# Access Compliance Report

## Public Rights-of-Way

### (Curb Ramps)

Intersection ID: 31699	Main Street: TIMBERTOP_LN	Cross Street: TIMBERTOP_LN	Location: SW
ADA ID: 15C3FE9F631F	Ramp Type: PerpDiag	Initial Pass/Fail: Fail	Overall Compliance: No
Severity Score: 33.75			
Codes/Mitigation Info/Possible Solution		Field Measurements/Component Compliance

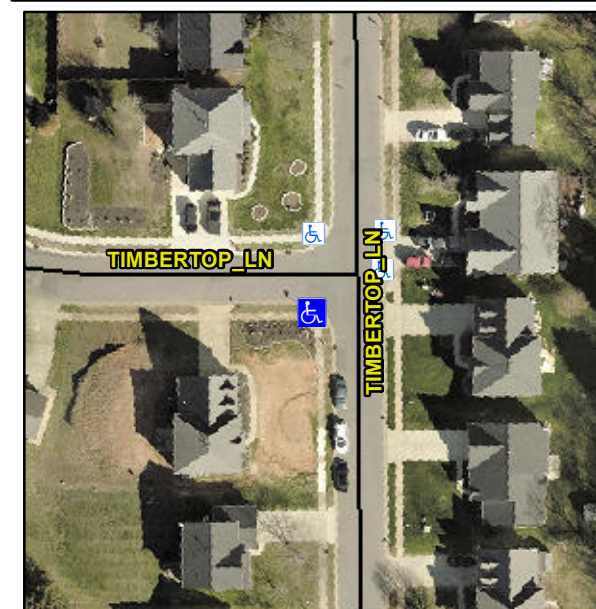
**Not Found, R304.5.1, R304.5.3**

Compliance	Description	Data	Compliance	Description	Data
N/A	Ramp Length (in)	51.0	Yes	Ramp Slope (%)	7.1
No	Ramp Width (in)	47.5	No	Ramp XSlope (%)	13.2
N/A	Flare Type LT	N/A	N/A	Flare Type RT	N/A
N/A	Flare Slope LT (%)	N/A	N/A	Flare Slope RT (%)	N/A
N/A	Flare Traversable LT?	N/A	N/A	Flare Traversable RT?	N/A
N/A	Landing Length (in)	N/A	N/A	DWS Provided?	N/A
N/A	Landing Width (in)	N/A	N/A	DWS Contrast?	N/A
N/A	Landing Slope (%)	N/A	N/A	DWS Length (in)	N/A
N/A	Landing X Slope (%)	N/A	N/A	DWS Full Width?	N/A
N/A	Landing Curb? (Y/N)	N/A	N/A	DWS Offset (in)	N/A
N/A	Shared Landing?	N/A			
N/A	Gutter Ponding?	N/A	N/A	Gutter Slope (%)	N/A
N/A	Gutter Lip Ht (in)	N/A	N/A	Gutter X Slope (%)	N/A
N/A	Painted X Walk1?	No	N/A	Painted X Walk2?	No
	X Walk 1 Direction	To E		X Walk 2 Direction	To N
N/A	X Walk 1 Width (in)	N/A	N/A	X Walk 2 Width (in)	N/A
	X Walk 1 Slope (%)	4.8		X Walk 2 Slope (%)	2.5
	X Walk 1 X Slope (%)	5.1		X Walk 2 X Slope (%)	7.6

N/A	Ramp inside XWalk1?	N/A	N/A	Ramp inside XWalk2?	N/A
	Road Slope (%)	10.5	N/A	Clear Space?	N/A
	Road X Slope (%)	2.2	N/A	Clear Space to XWalk (in)	N/A
N/A	Any Obstructions?	N/A	N/A	Storm Grate/Utility Hazard?	N/A
	Obstruction Type			Storm Grate/Utility Type	
		N/A			N/A
			Yes	Surface Condition? (G/P)	Good

**Remove & Replace Curb Ramp With Two New Directional Ramps or Equivalent.**
